# HI-STAR 100 Impact Limiter Benchmarking

Presentation to NRC  
September 2, 2008

# HI-STAR 180 OTIs related to HI-STAR 100 Benchmarking

## 2-3, 2-6: Hex vs. Tet, Mesh Sensitivity

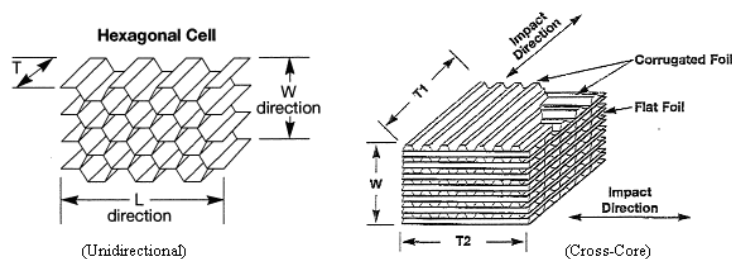
- We are currently in the process of converting all sections of the crush material that were modeled as tets to hex
- Some areas need (justifiable) approximations
- Parametric studies show variations of maximum decelerations within +/- 20%
- Previously used tet elements appear to overstate the softness of the material
- Mesh Sensitivity Evaluations will include parametric studies on simplified representative geometries

## Preliminary Results, End Drop

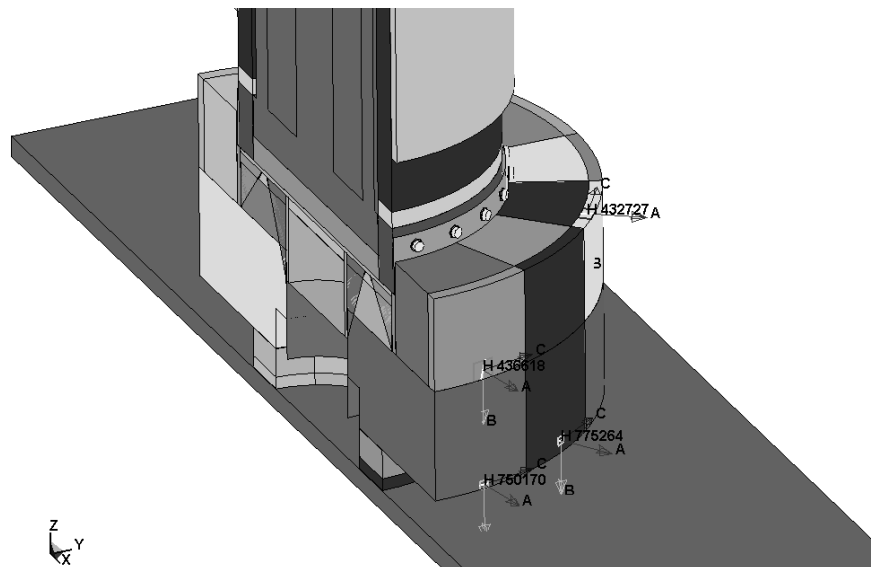
- 1/4 scale test: 216 g
- Initial benchmark calculations (Phase 3): 228 g
- Updated benchmark calculations:
  - Rigid Body: 216 g
  - Three accelerometers, averaged: 212 g
